colingillmor@ti.com

Hi Eddie.

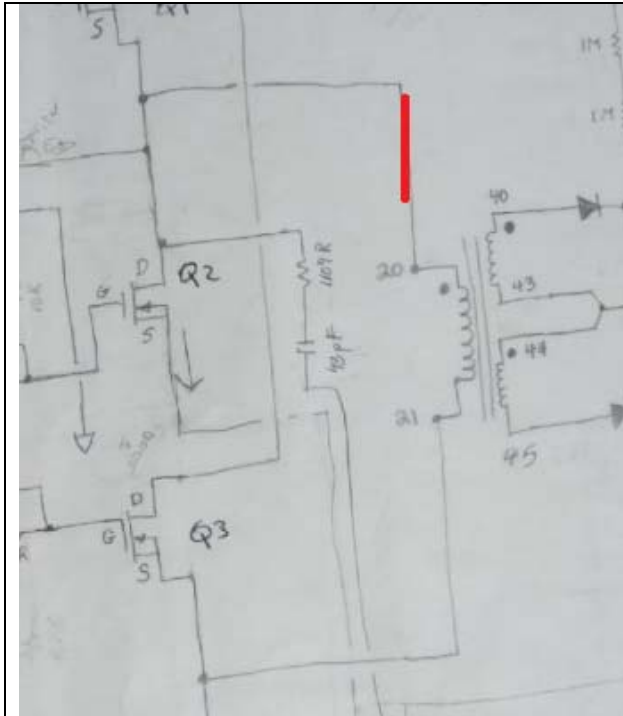
Please check that the GND connection to the gate driver is correct (Pin 3)

| | <p>You are not using OUTE or OUTF so you should leave these pins open circuit.</p> <p>You can also tie the DCM pin to VREF to disable the OUTE and OUTF signals. This may slightly reduce the amount of noise in the system.</p> <p>Shorting the DCM pin to GND, as you have done, is OK but the OUTE and OUTF signals will remain enabled.</p> |
| | <p>I was not able to find of the Current Transformer primary. It should be at the location marked here. Double check the phasing of the primary / secondary.</p> |
| | <p>You don't have a reset network for the current transformer. This is needed so that the core flux can reset during the interval between switching cycles. There are a number of ways to do this but a resistor is usually sufficient. I'd use a reset resistor (R2) which is 100 times larger than the burden resistor (R1).</p> <p>http://www.ti.com/lit/ds/symlink/ucc28951-q1.pdf</p> <p>Section 8.2.2.10 has some details of a typical calculation.</p> |

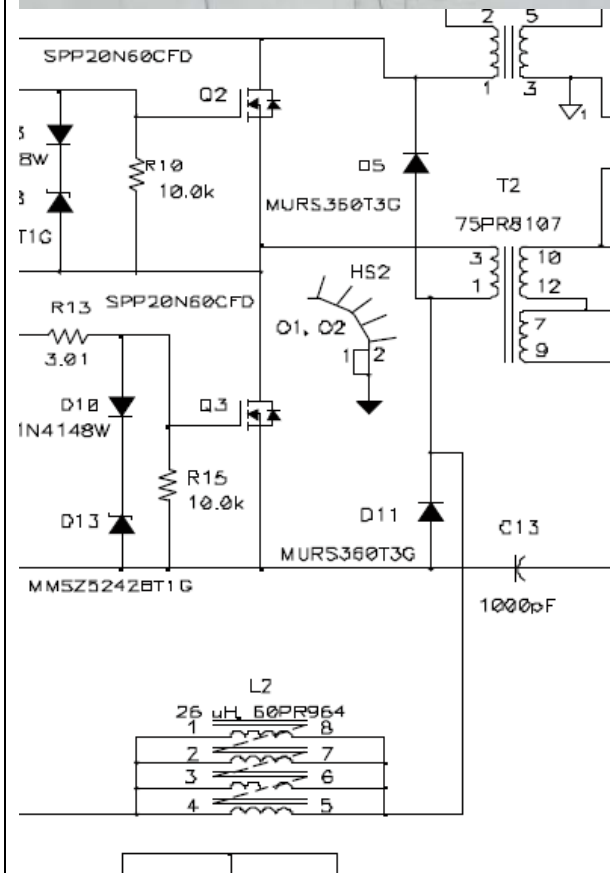
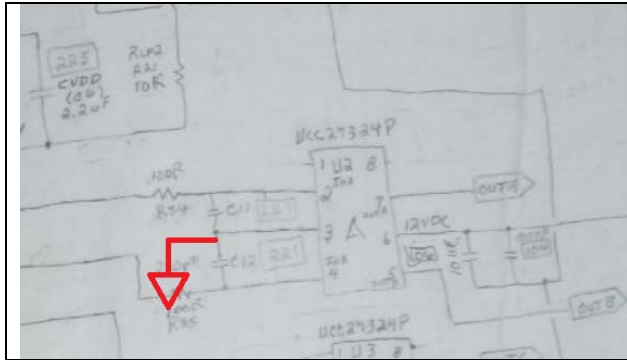
You don't have a separate shim inductor and clamp diodes. The shim inductance + Leakage inductance ensures enough energy is stored to force ZVS. For now – I'd leave it alone but you might want to review the calculations for the shim/leakage inductance. They are included in the Excel calculator for the controller which you can find on the product page. The shim inductor is L2 and the clamp diodes are D5 and D11 in the EVM schematic.

I don't see a GND connection at pin 3 of the driver ICs – I'm sure it's there but please double check.

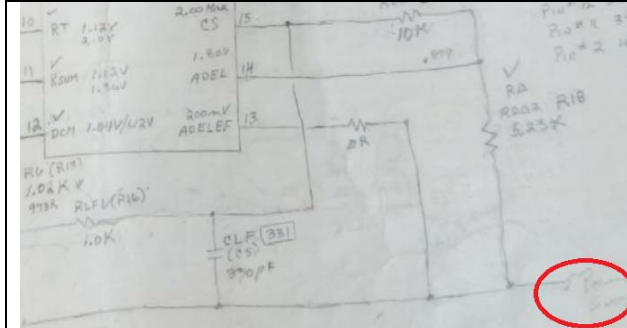
DCM may be left connected to GND but later you can connect it to VREF and that will disable the OUTE, OUTF signals.

The red node should be connected to the GND pin of the IC through a VERY low impedance connection. It's not clear from the schematic.

These are the signals at the output of the GDT. Please check the OUTx signals at the pins of the controller and again at the input to the gate driver IC and at the output of the gate driver IC. I expect that all the signals will be nice square waves.

The ringing is due to the transformer secondary inductances being resonant with the transformer stray capacitance.

The dead times are those marked by white lines – they look ok for now although they may need adjusting a bit.

IS IT MY DELAY TIME, DEAD TIME? WHAT EVER IT IS, IT IS CHANGING THE SIGNAL COMING FROM THE UCC28950 IC. THIS TELS ME IT IS EITHER THE FEEDBACK PIN 4, CURRENT SENSE PIN 15, VDD RAIL?

The feedback loop will have a bandwidth less than 15kHz so it cannot be responsible for changes at MHz frequencies. I believe the ringing is due to the GDT inductance ringing with its self capacitance. Once the secondary is loaded by the MOSFET gate the ringing should disappear.

WHATS HAPPENING TO THE OUTA, B, C, D SIGNALS ARE NOT BECAUSE OF THE LOAD, BECAUSE WHAT HAPPENS TO THE LOAD CAN NOT GO BACKWARDS THRU THE GDT AND CAUSE IT TO CHANGE.

I expect that the OUTx signals are ok.

FIGURE 2. TOP WAVEFORM Q1 Q2 AT MOSFET GATE, BOTTOM WAVEFORM Q3 Q4 AT MOSFET GATE NO DC LINK

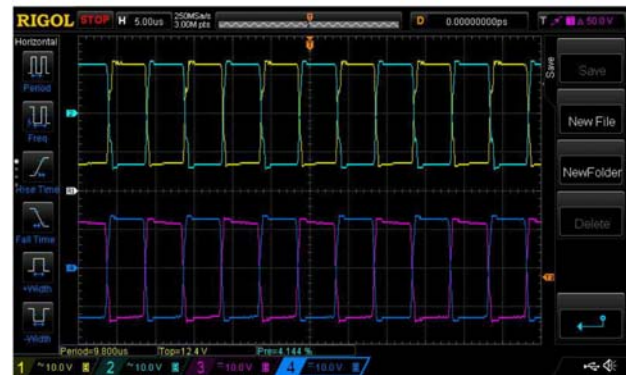
These waveforms look ok for now.
